**RESPONSE TO PUBLIC COMMENTS ON THE  
MAY 2012 DRAFT OF**

***AN ASSESSMENT OF POTENTIAL MINING IMPACTS ON  
SALMON ECOSYSTEMS OF BRISTOL BAY, ALASKA***

U.S. Environmental Protection Agency

Figure 1. Comparison of Milling Rate for Mines in Alaska/BC & EPA’s Hypothetical Mine<sup>13</sup>

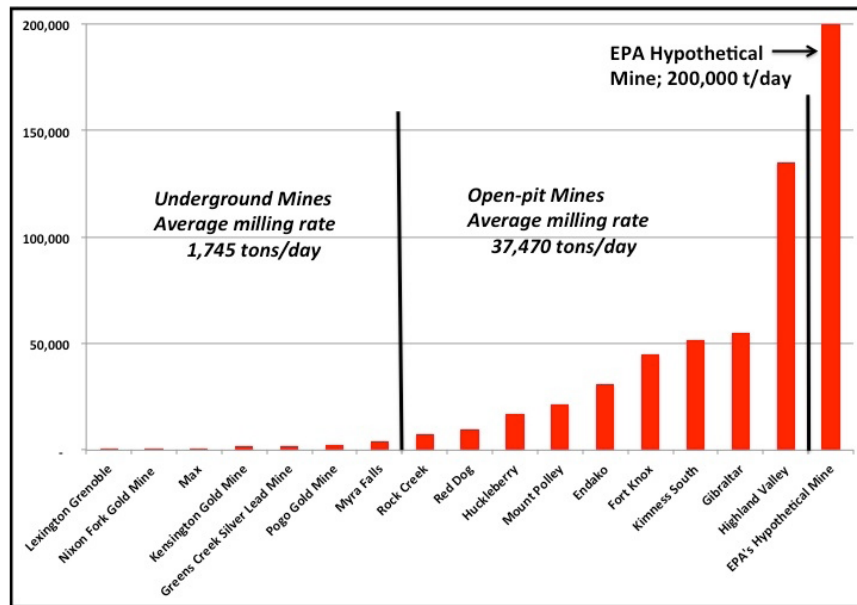
Figure 1 shows the milling rate for mines in British Columbia and Alaska. (Appendix A explains the data sources for the figure). The figure shows that the Assessment’s hypothetical mine is much larger than any mine in Alaska or British Columbia. In fact, the average open-pit mine in the two areas mills an average of 37,470 tons/day. EPA’s hypothetical mine assumes 200,000 tons/day, which is more than is five times larger than this average.
